SERVICE ACTION

Service Action Number:
Q079

Subject: Suspension Ride Height Sensors – Corrosion and Air Suspension Ride Levelling Control Module (RLM) Software Update	Publication No.:	204-Q079
	Model:	Discovery 3
	Model Year:	2008 – 2009
	VIN Range:	LA461580 – LA513324
	Model:	Range Rover Sport
	Model Year:	2008 – 2009
	VIN Range:	LS144333 – LS215577
	Date of Issue:	15 January 2010
Expiry Date:	31 January 2012

RE: Ride Height Sensors – Corrosion and Suspension RLM Software Update

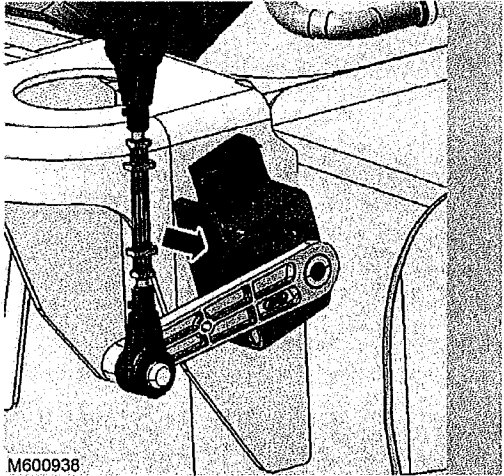
<p>1</p>	<p>Note: Left-hand side shown, right-hand side similar. Inspect ride height sensor bracket position for hole orientation (see Fig. 1).</p>	 <p>M600938</p>
<p style="text-align: right;">Fig. 1</p>		
<p>2</p>	<p>If the ride height sensor bracket is installed as shown in Fig. 2, carry on from step 5, if not carry on from step 3.</p>	 <p>M600938</p>
		<p style="text-align: right;">Fig. 2</p>

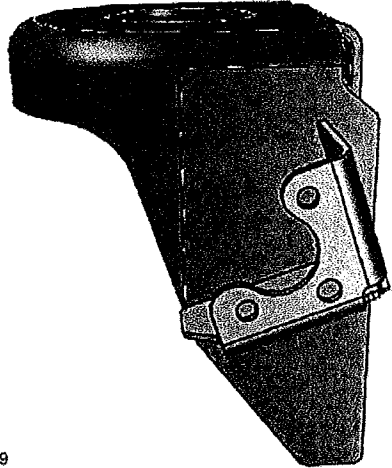
<p>3</p>	<p>Note: This condition only affects a small number of chassis frames of vehicles built at the end of 2009.</p> <p>If the ride height sensor bracket is installed as shown in Fig. 3, carry on from step 4.</p>	 <p>M600939</p>
<p>Fig. 3</p>		<p>4</p> <p>Remove the two screws and remove the bracket from the new ride height sensor (see Fig. 4)</p>  <p>M600940</p>
		<p>Fig. 4</p>
